Re: Initial Submission Review – Vega Collegiate Academy - Advisory Site Plan

Application Number: **DA-2255-00**
Case Number: **1992-6017-06**

Initial Submission Review

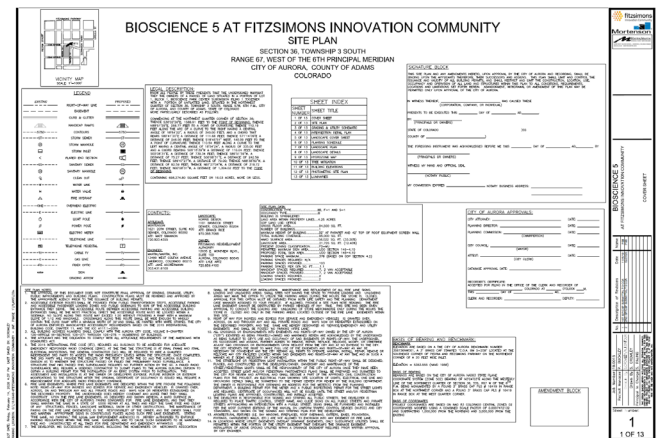
2D. Include an amendment block on the cover sheet (attached).
